ADDENDUM No. 2

Percival Soccer Field

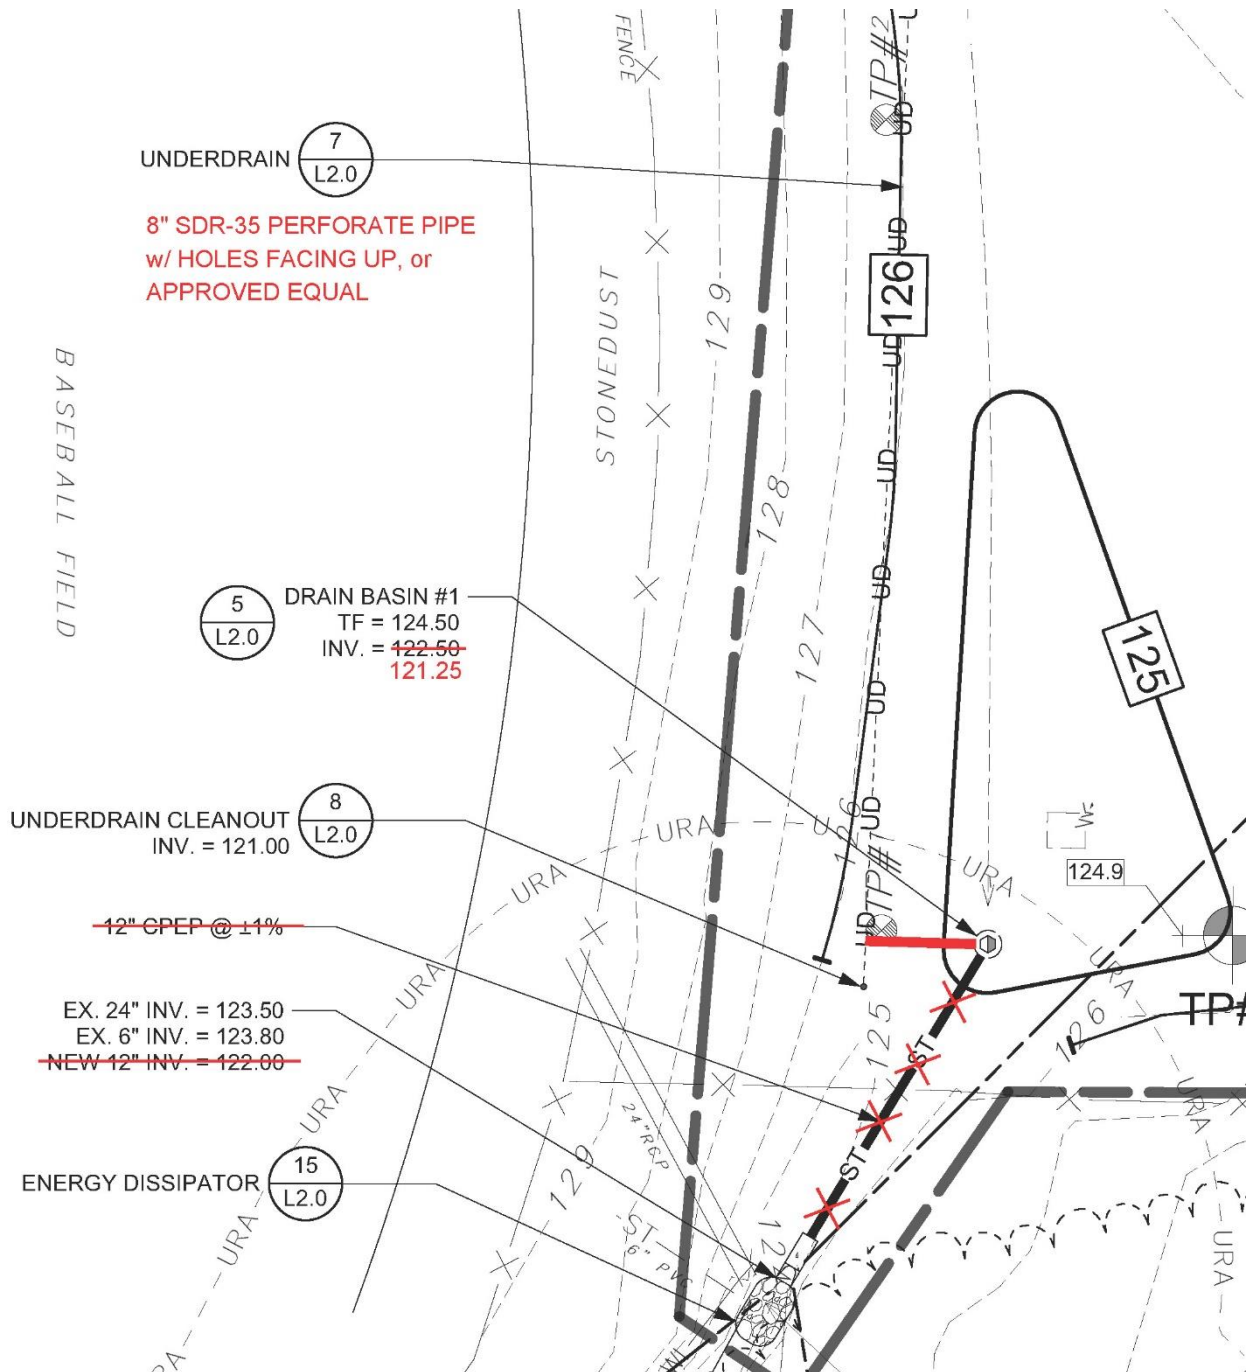
1. Change underdrain to SDR-35 8-inch perforated pipe, holes on top, and tie DB #1 into it. See sketch included here. Work shown at existing 24-inch pipe inlet, clearing and riprap, is still part of the contract.
